Environment Agency

Decision document recording our decision-making process following review of a permit

The Permit number is: EPR/EP3133RZ
The Operator is: Uniper UK Limited
The Installation is: Ratcliffe On Soar Power Station
This Variation Notice number is: EPR/EP3133RZ/V006

Figure 1. Schematic of UK freshwater plant and the flows of discharge streams to water

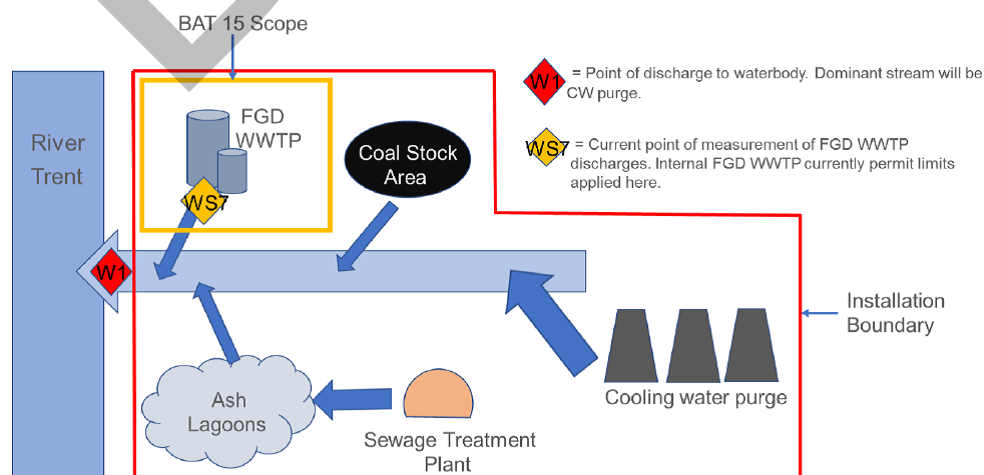
For this installation, the Operator has confirmed that releases to surface water from the site arise from many sources including ash lagoons, coal stockyard run-off, surface water drains, FGD waste water treatment plant, sewage treatment plant and cooling water purge. Where required, these individual releases are treated separately before being combined into a single waste water stream prior to release at the site boundary as shown in Figure 1 below.

The BAT-AELs stated in the LCP BREF BAT Conclusion 15 are applicable at the point of release to water body i.e. at W1 in Figure 1 the installation boundary, with FGD WWTP emissions only falling in scope.

Currently the permit sets a minimum flow of 700l/s at W1 before discharge at WS7 is permitted. On this basis with exception of Total Suspended Solids of the Operator proposes compliance with BAT-AELs be demonstrated at the point of discharge by application of relative flow balances measured at W1 (final site discharge) and WS7 (FGD WWTP) and is accepted.
